Addendum D2

re: **FORT WAYNE COMMUNITY SCHOOLS**
Renovations at Brentwood, North Side, and Northcrest
 111032.01

issue date: **February 13, 2026**

Addendum: 2
Date: 2/13/2026
Project: FWCS Brentwood NSHS Northcrest

Enlarged Floor Demolition Plans

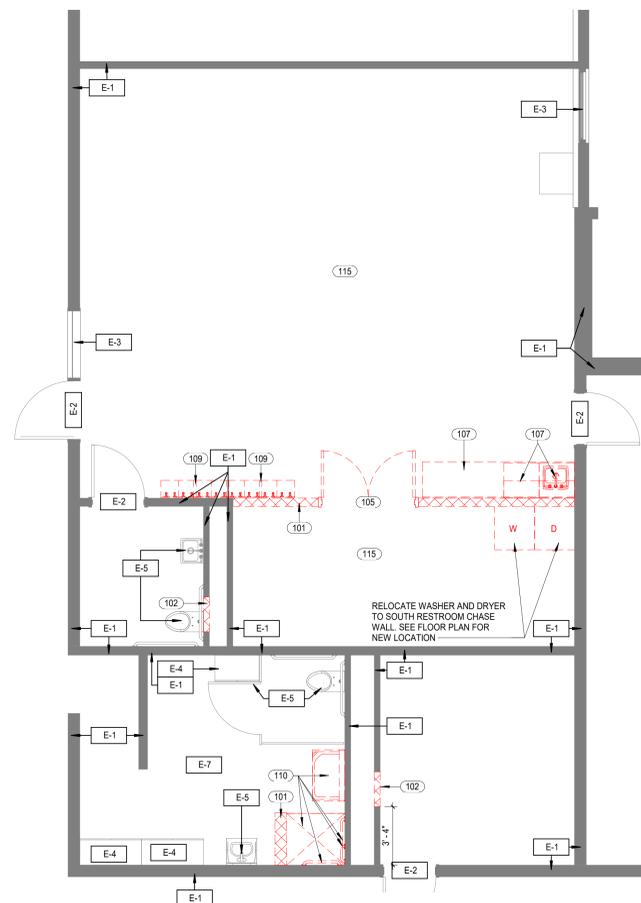
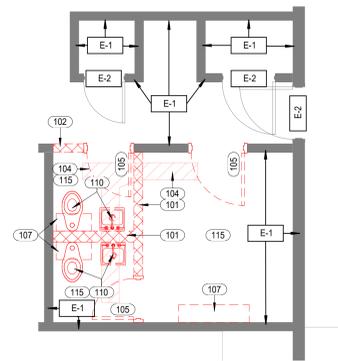
ITEM	LOCATION	DESCRIPTION
A2.01	SPECIFICATION 096723 (Reissued)	<u>CHANGE:</u> Specification section 096723 – Treadwell Decorative Chip reissued as part of this addendum to change installation method on tile substrate.
A2.02	DRAWING BW-A1.20 (Drawing Reissued)	<u>CLARIFICATION:</u> Sheet BW-A1.20 reissued to correct overlap between the existing to remain legend and the specific demolition notes legend.
A2.03	DRAWING BW-A1.20 (Drawing Reissued)	<u>CLARIFICATION:</u> Sheet BW-A1.20 reissued to include clarification on specific demolition note #111.

- 111 CONTRACTOR SHALL REMOVE & SALVAGE EXISTING CARPET TILE (INDICATED BY DIAGONAL LINES) FOR REINSTALLATION. REFER TO INTERIOR FINISH PLAN FOR INSTALL LOCATIONS. REMAINING SALVAGED CARPET TILE TO BE RETURNED TO OWNER. CONTRACTOR SHALL COORDINATE CARPET REMOVAL WITH SLAB DEMOLITION TO ENSURE THAT EXISTING AND SALVAGED CARPET REMAINS UNDAMAGED.

First Floor Lighting Plan

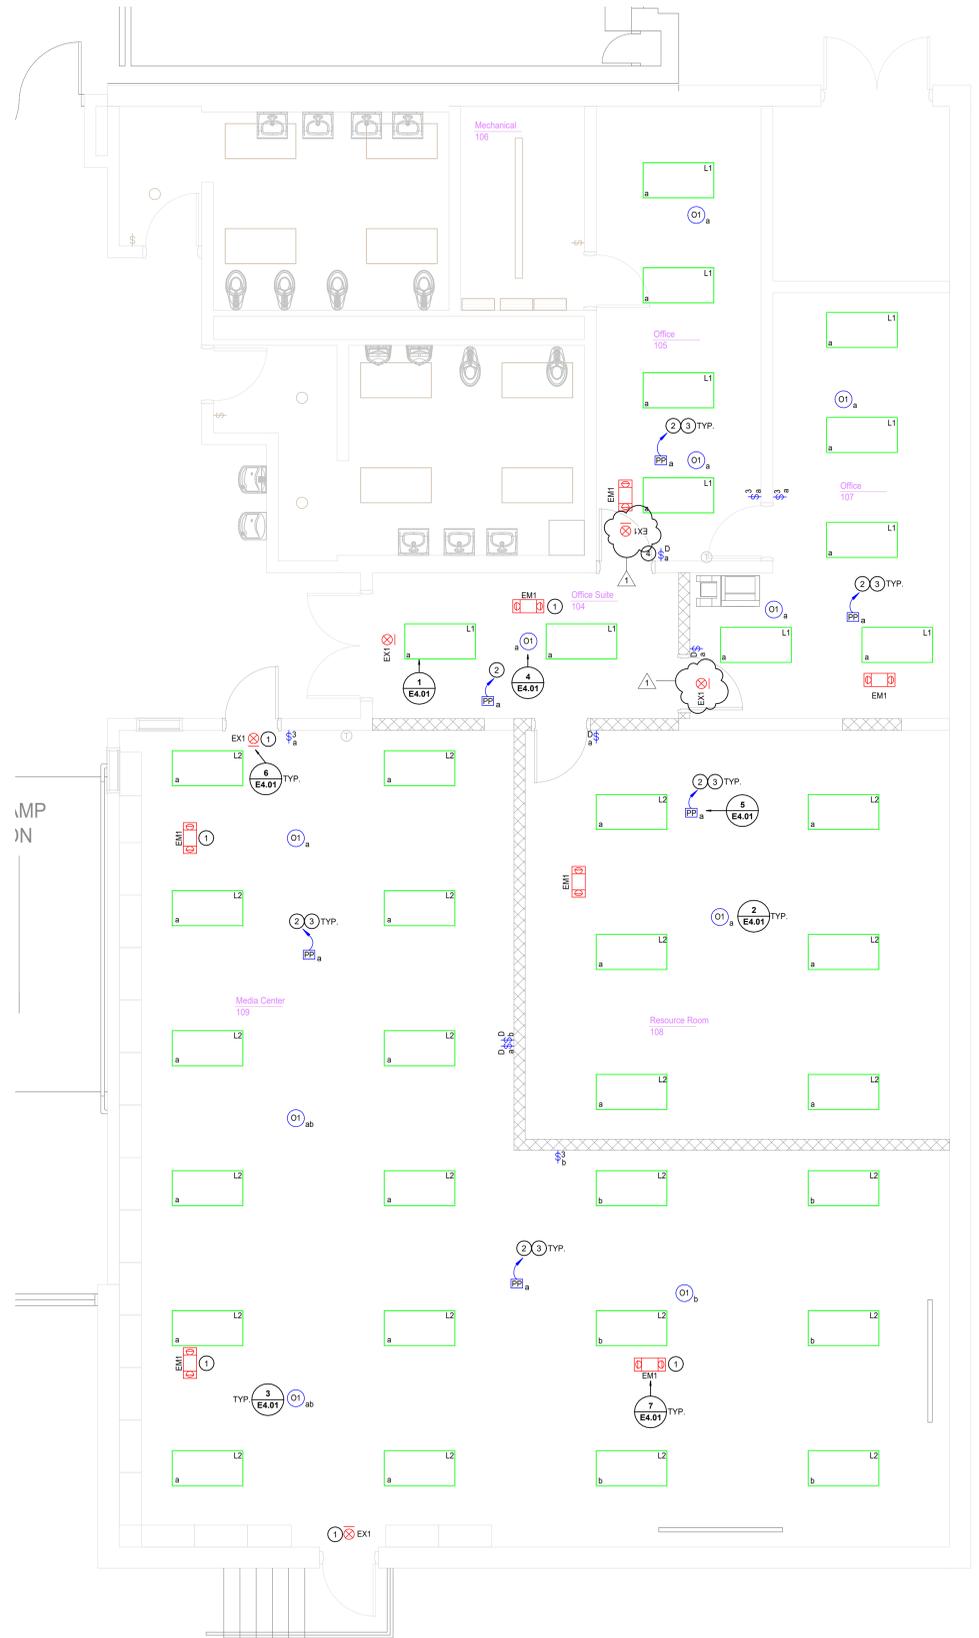
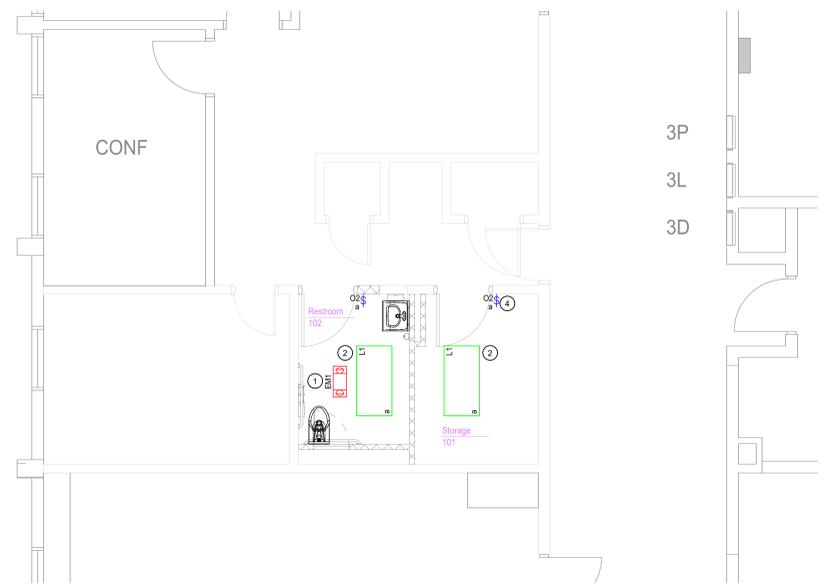
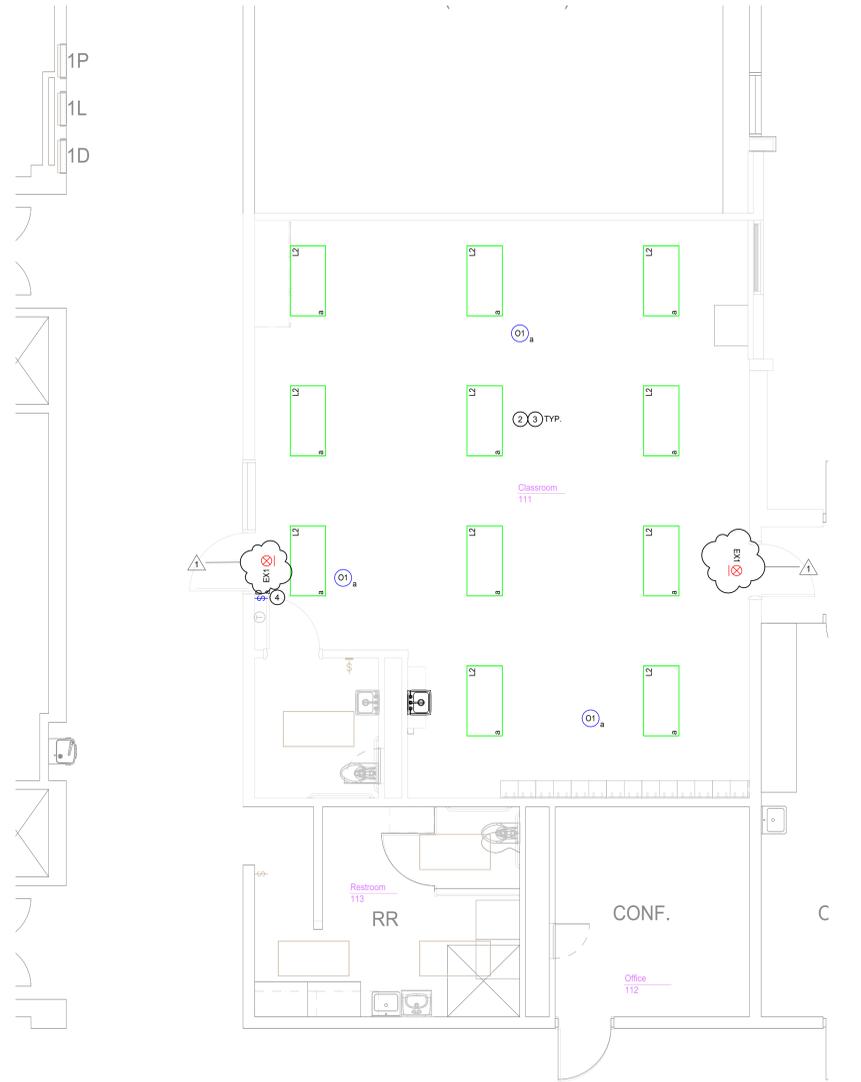
Item #2: Drawing Sheet BW-E3.01, First Floor Lighting Plan

- A. Emergency Exit (EX1) fixtures added to Offices 105,107 and Classroom 111. Refer to supplemental drawing BW-E3.01 for more information.

First Floor Lighting Plan

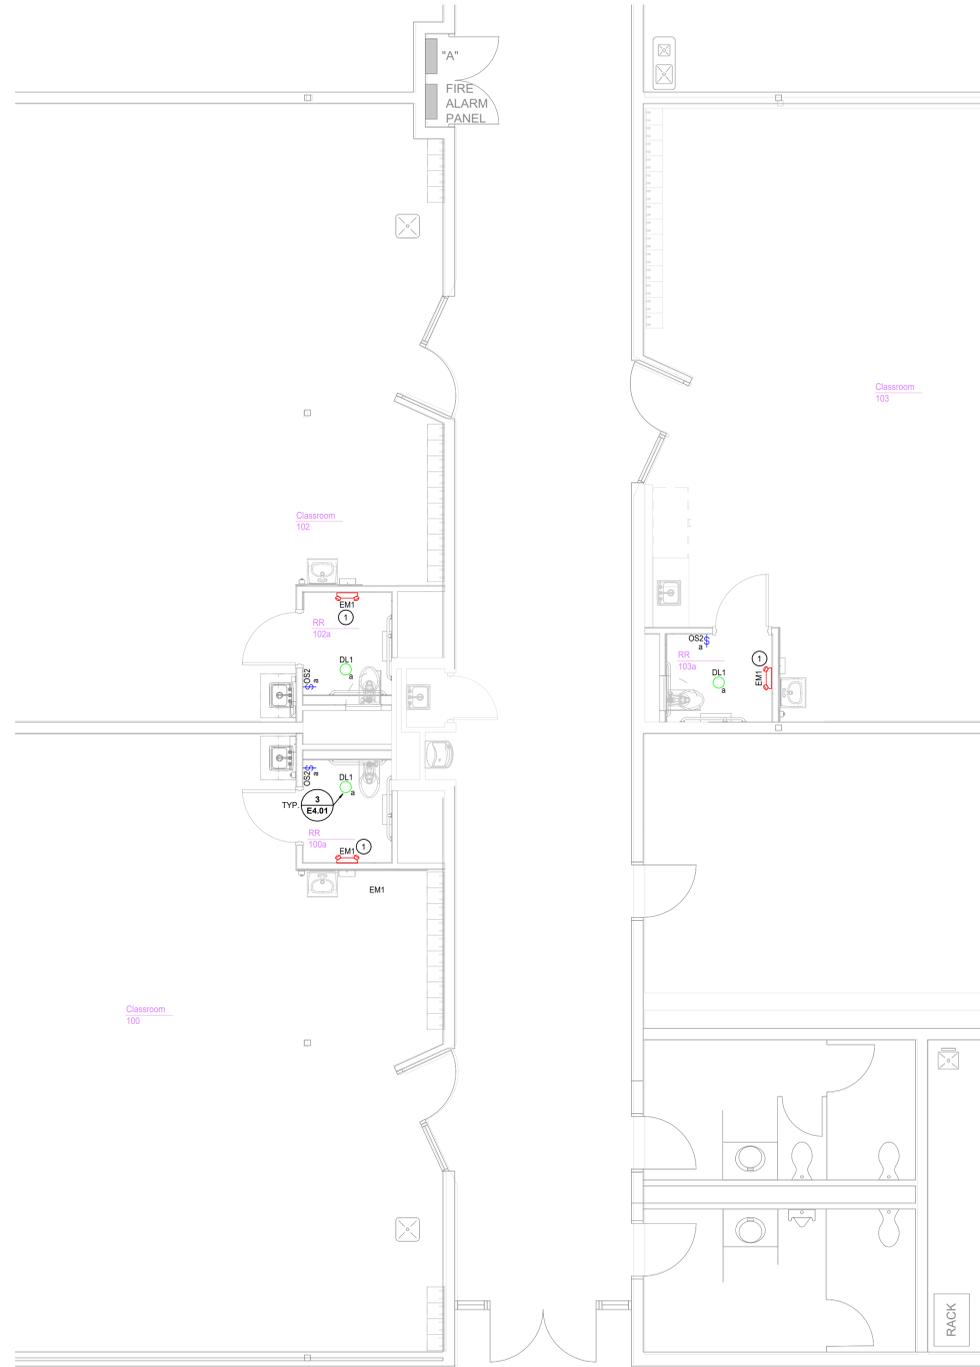
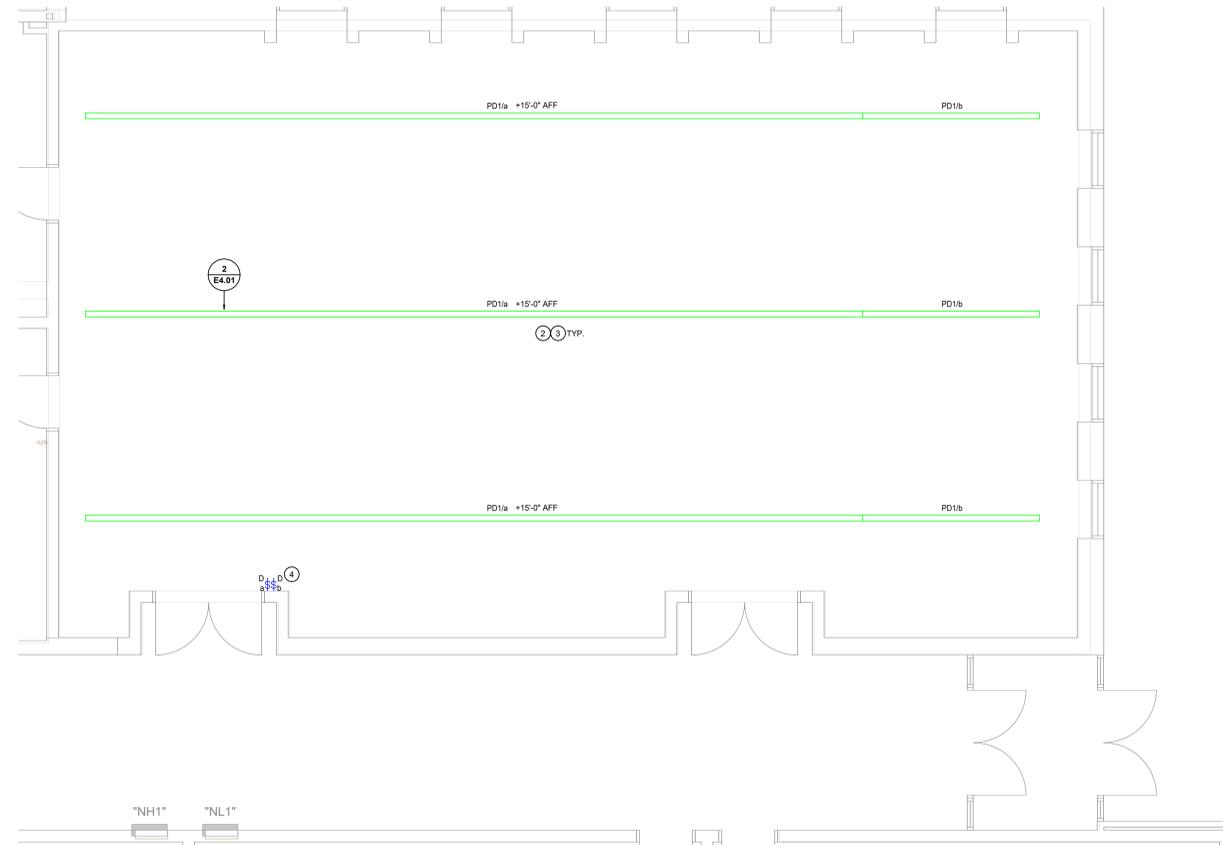
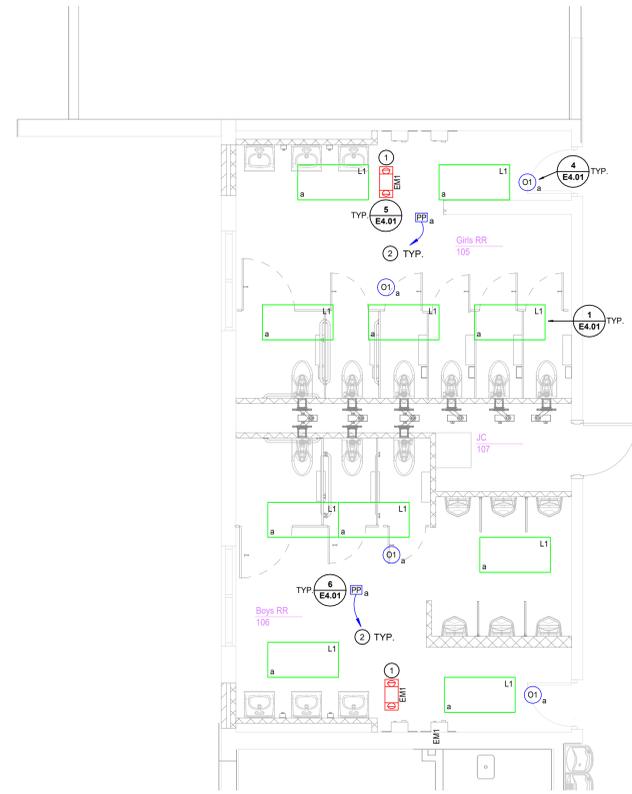
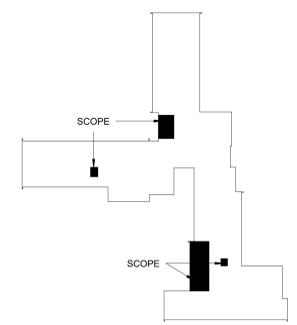
Item #4: Drawing Sheet NC- E3.01, First Floor Lighting Plan

- A. Revised Plan notes, for clarity. Refer to supplemental sheet for additional information.
